## Bodybuilder's Bulletin

**Bulletin No. 105 (to be read in conjunction with Bulletin No. 103)**

### Power Supply and Ground Connections for Auxiliary Consumers

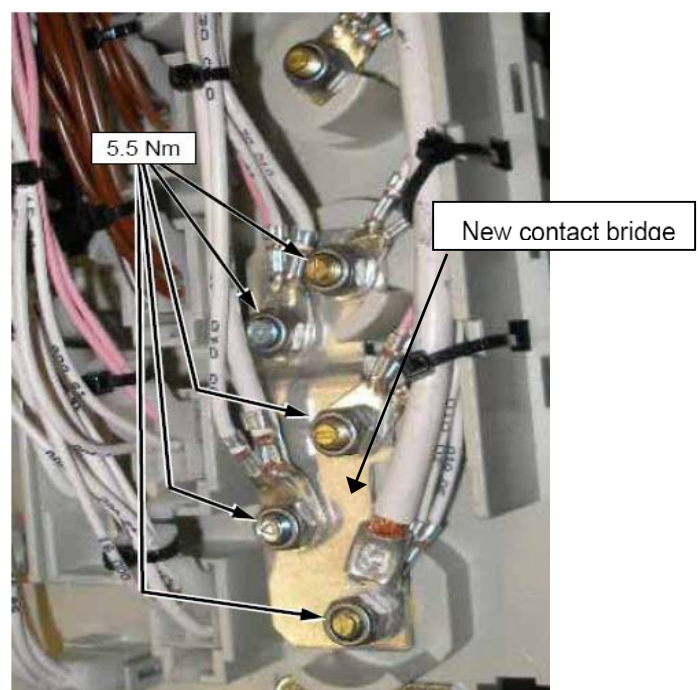
It should be noted that it may not be possible to add connections for additional consumers to Pins 90 and 91 on the rear of the Central Electrics board for current TG product (all models).

This is because there may be insufficient room for the lock nut to secure correctly after insertion of the additional terminals.

There must always be at least one full thread visible beyond the locking medium once the nut is fully tightened.

Where extra space is required, it is possible to install a new contact bridge (81.25908.0067) after first removing the original items and discarding them – see photos below. Nuts to be tightened to 5.5 Nm.
